Bulletin: #16-02

Product Release Notice

Power Sweep Features

Product: 8" and 10" Standard and HD Power Sweeps

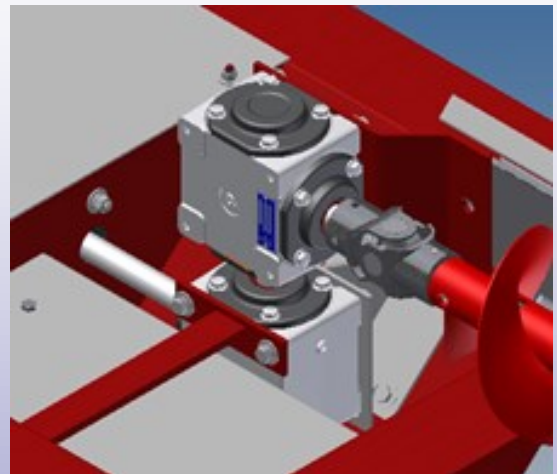
Product Improvement Overview: All new Power Sweeps will now come standard with the new Sweep End - Wheel (PRN 16-01), a new gearbox to reduce the shaft to get the sweep closer to the floor (estimated 1" off bin floor), and extend the flight and shield bundles to get the auger flight and end wheel closer to the bin wall.
